Contract No. T201707403.01
Federal Aid Project No. BHN-N006(17)
Rehabilitation of Bridges 1-600, 1-601, AND 1-604, SR2 AND SR141 Interchange
New Castle County

Enclosed is Addendum No. 3 for the referenced contract consisting of the following:

3. Nine (9) sheets, Construction Plans, sheets 3, 19, 43, 51, 56, 61, 79, 103 and 112, revised, to be substituted for the same sheets in the Plans.

ADDENDA AND REVISIONS

SHEET NO. 43

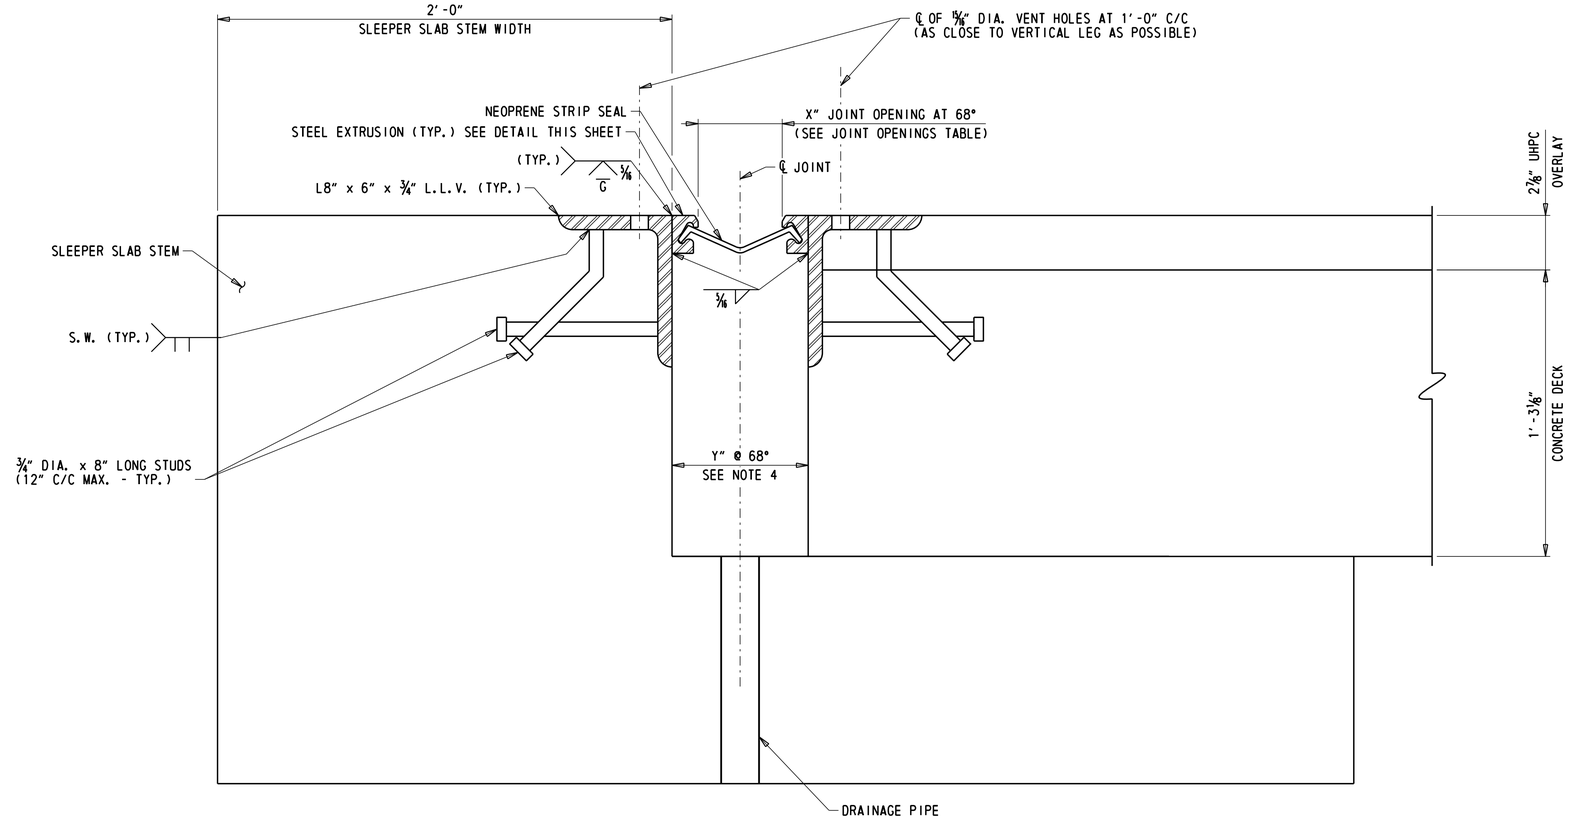
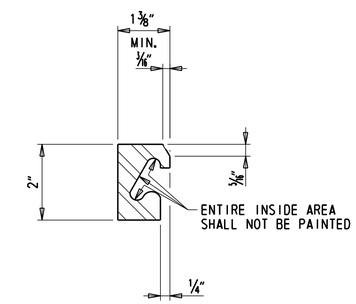
3 ~~9. STEEL EXTRUSIONS AND JOINT ANGLES SHALL BE CONTINUOUS ACROSS THE FULL WIDTH OF THE ROADWAY, NO SPLICING WILL BE PERMITTED.~~

3 9. AT AREAS WHERE STEEL MEMBERS ARE TO BE SPLICED, THE USE OF COMPLETE JOINT PENETRATION (CJP) AND PARTIAL JOINT PENETRATION (PJP) WELD ARE BOTH PERMITTED. THE THICKNESS OF THE PJP WELD MUST BE A MINIMUM OF HALF OF THE STEEL MEMBER THICKNESS.

3 10. THE CONTRACTOR SHALL SUBMIT A WORKING PLAN FOR PLACEMENT OF THE STRIP SEAL DUE TO PHASING.

DK-08
SECTION
WRA
SHEET NO.
51

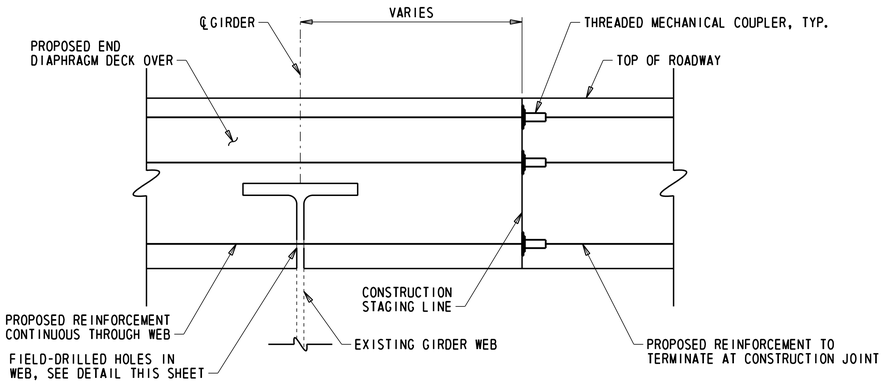
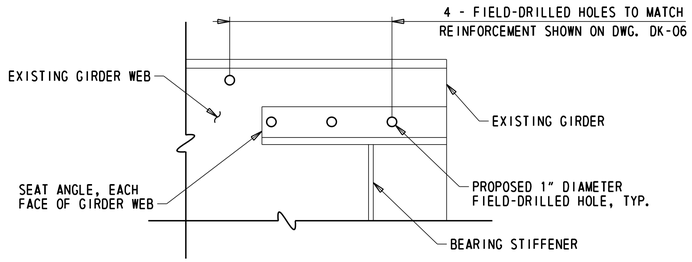
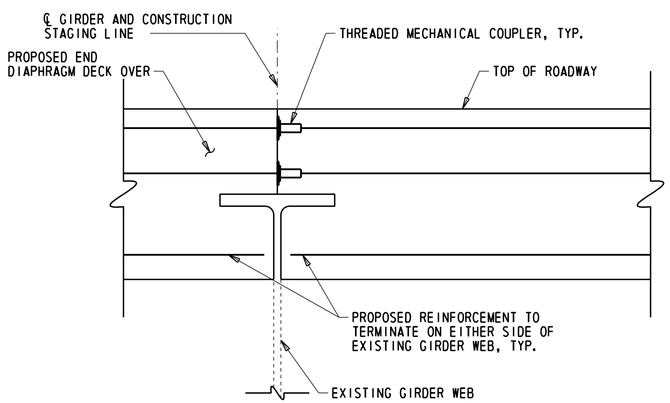
△3 END DIAPHRAGM DECK OVER CONNECTIONS: C-D, E-F, J-K, L-M

△3 END DIAPHRAGM DECK OVER CONNECTIONS: C-D, E-F, J-K, L-M

△3 END DIAPHRAGM DECK OVER REINFORCEMENT DETAILS

△3 1. SPLICES IN REINFORCEMENT BETWEEN CONSTRUCTION STAGES SHALL USE THREADED COUPLERS. ALL THREADED COUPLER HARDWARE SHALL MEET OR EXCEED 125% OF BAR REINFORCEMENT YIELD STRENGTH. PAYMENT FOR THREADED COUPLERS WILL BE INCIDENTAL TO ~~ITEM 611001 - BAR REINFORCEMENT, EPOXY COATED.~~ ITEM 611000 - BAR REINFORCEMENT.

△3 2. PAYMENT FOR GIRDER WEB FIELD-DRILLED HOLES WILL BE INCIDENTAL TO ~~ITEM 611001 - BAR REINFORCEMENT, EPOXY COATED.~~ ITEM 611000 - BAR REINFORCEMENT.

△3 3. FIELD-DRILLED HOLES IN EXISTING GIRDER WEB NOT REQUIRED AT CONNECTIONS BETWEEN END DIAPHRAGM DECK OVER UNITS A-B AND UNITS G-H. ASSOCIATED REINFORCEMENT TO TERMINATE ON EITHER SIDE OF EXISTING GIRDER.

SECTION	SHEET NO.
WRA	103

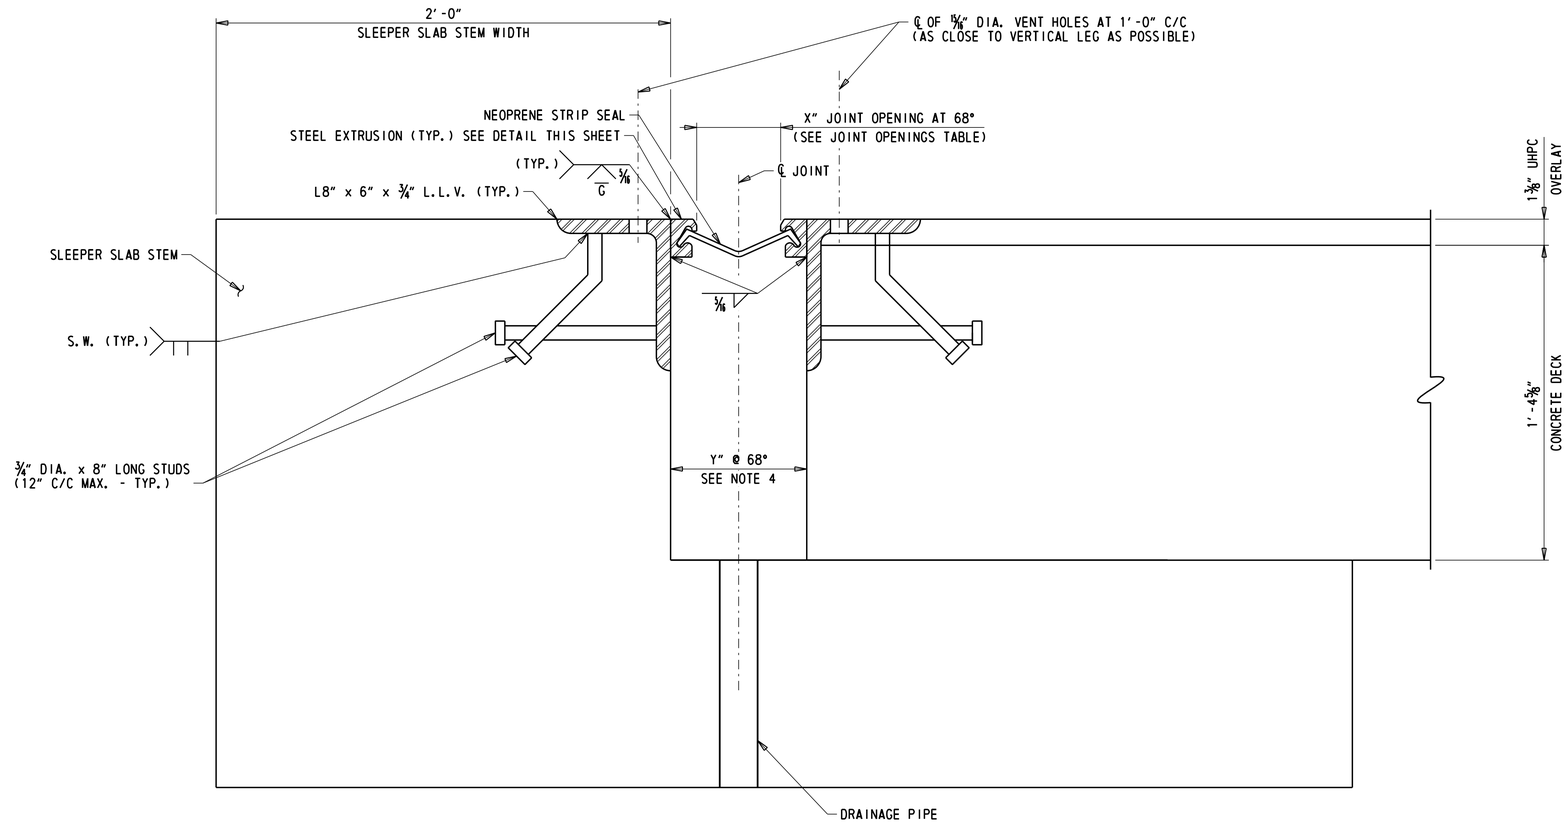
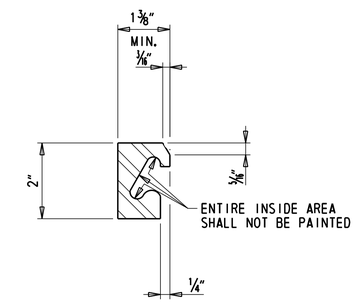
3 ~~9. STEEL EXTRUSIONS AND JOINT ANGLES SHALL BE CONTINUOUS ACROSS THE FULL WIDTH OF THE ROADWAY, NO SPLICING WILL BE PERMITTED.~~

3 9. AT AREAS WHERE STEEL MEMBERS ARE TO BE SPLICED, THE USE OF COMPLETE JOINT PENETRATION (CJP) AND PARTIAL JOINT PENETRATION (PJP) WELD ARE BOTH PERMITTED. THE THICKNESS OF THE PJP WELD MUST BE A MINIMUM OF HALF OF THE STEEL MEMBER THICKNESS.

3 10. THE CONTRACTOR SHALL SUBMIT A WORKING PLAN FOR PLACEMENT OF THE STRIP SEAL DUE TO PHASING.

DK-09
SECTION
WRA
SHEET NO.
112

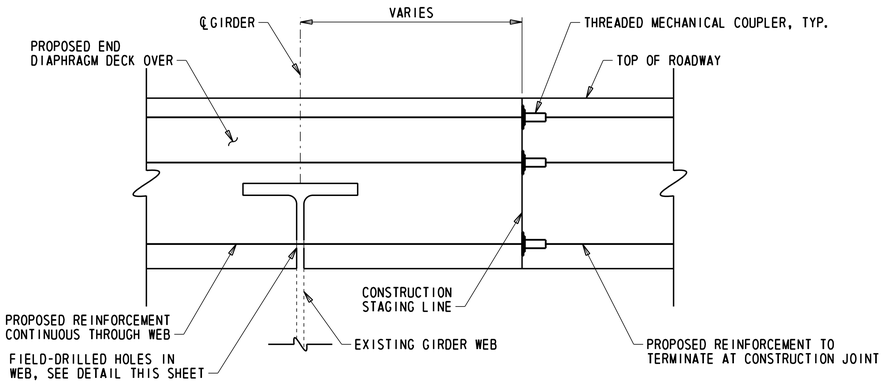
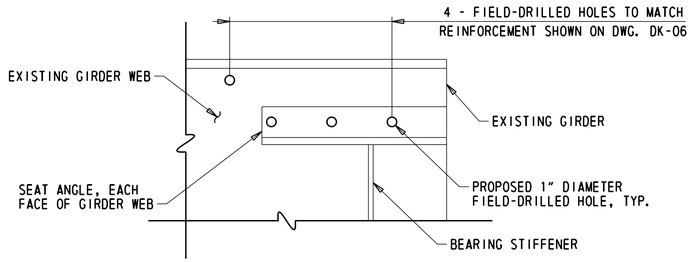
3 1. SPLICES IN REINFORCEMENT BETWEEN CONSTRUCTION STAGES SHALL USE THREADED COUPLERS. ALL THREADED COUPLER HARDWARE SHALL MEET OR EXCEED 125% OF BAR REINFORCEMENT YIELD STRENGTH. PAYMENT FOR THREADED COUPLERS WILL BE INCIDENTAL TO ~~ITEM 611001 - BAR REINFORCEMENT, EPOXY COATED.~~ ITEM 611000 - BAR REINFORCEMENT.

3 2. PAYMENT FOR GIRDER WEB FIELD-DRILLED HOLES WILL BE INCIDENTAL TO ~~ITEM 611001 - BAR REINFORCEMENT, EPOXY COATED.~~ ITEM 611000 - BAR REINFORCEMENT.
